STATE OF NORTH CAROLINA
DEPARTMENT OF TRANSPORTATION

April 12, 2013

Subject: **Additional Information in Response to the N.C. Division of Water Quality's On Hold Letter for the Modification Request of the Individual Section 404 and Section 401 Water Quality Certification** for the proposed improvements to NC 24 from SR 1853 (John Nunnery Rd.) in Cumberland to US 421-701/SR 1296 (Sunset Avenue) in Sampson County. Federal Aid Project No. STPNHF-F-8-2(17), TIP No. R-2303B, C, and D.

R-2303C Application Comments

PERMIT DRAWING
SHEET 51 OF 75

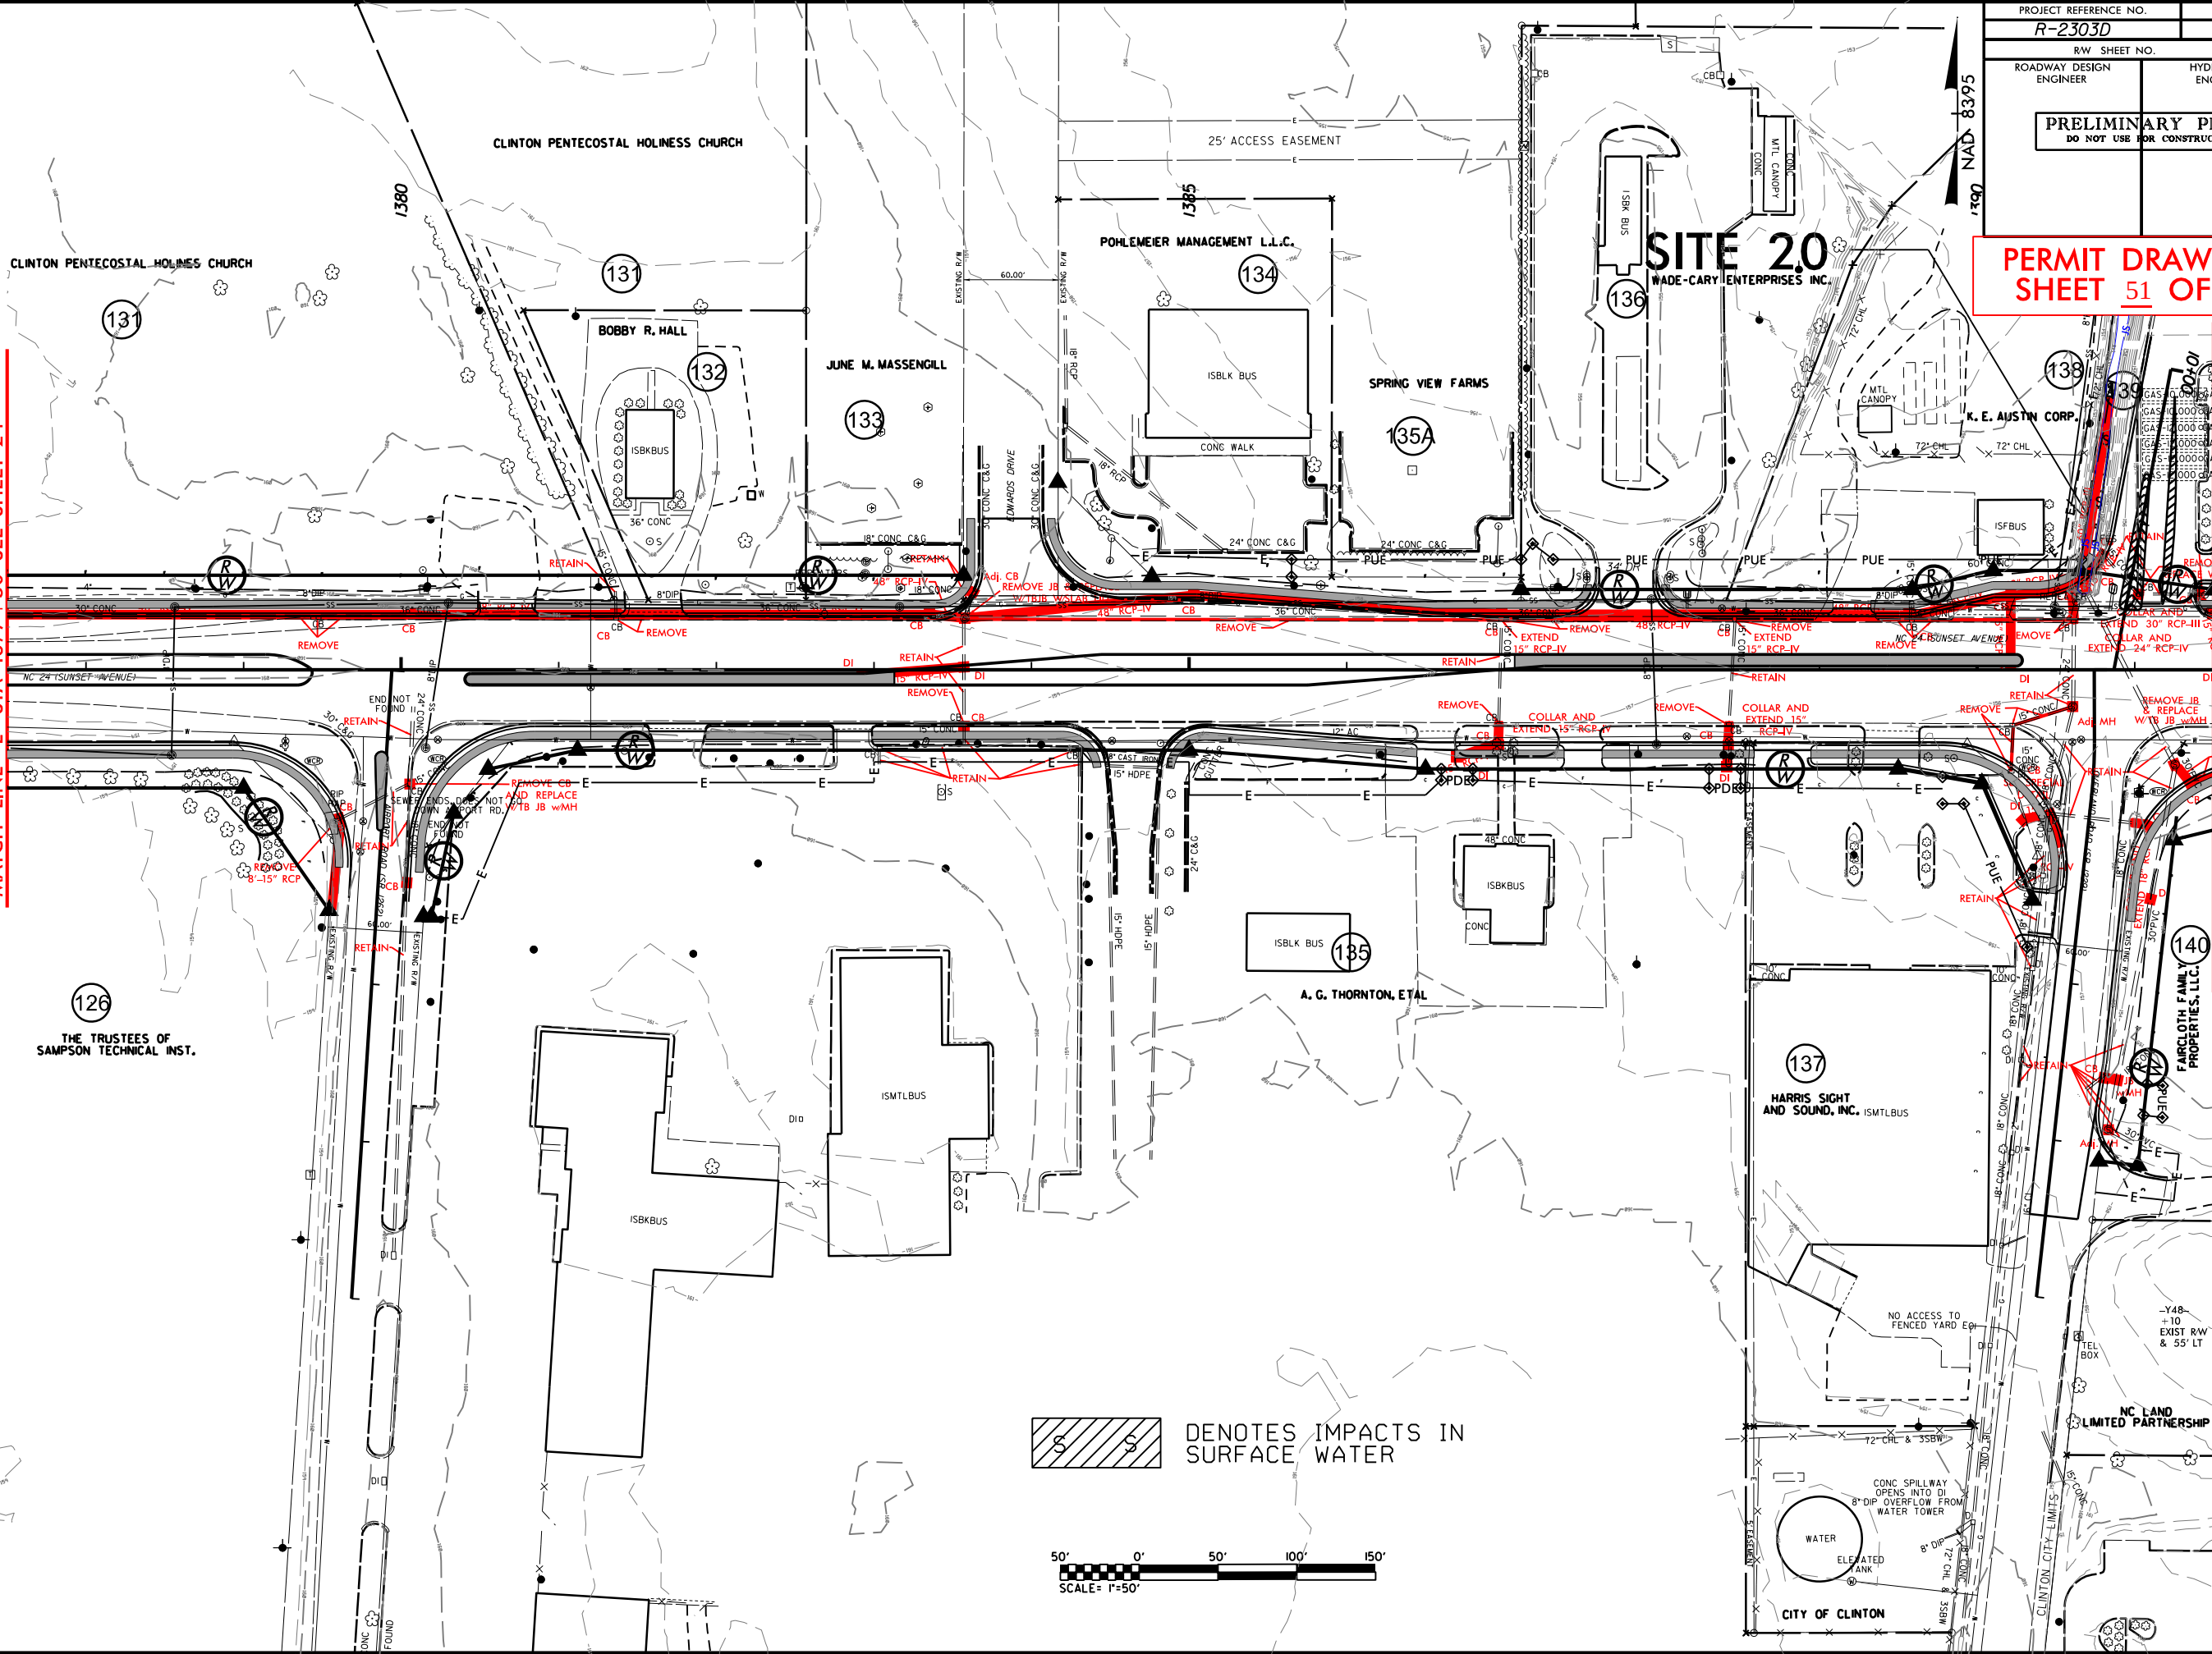
11. Permit drawing 51 of 75, shows 4:1 slopes on the outlet of this jurisdictional crossing. Your application states in the “Minimization and Avoidance” section states that 3:1 slopes will be used in jurisdictional areas. Please correct.

Slopes have been revised to 3:1.
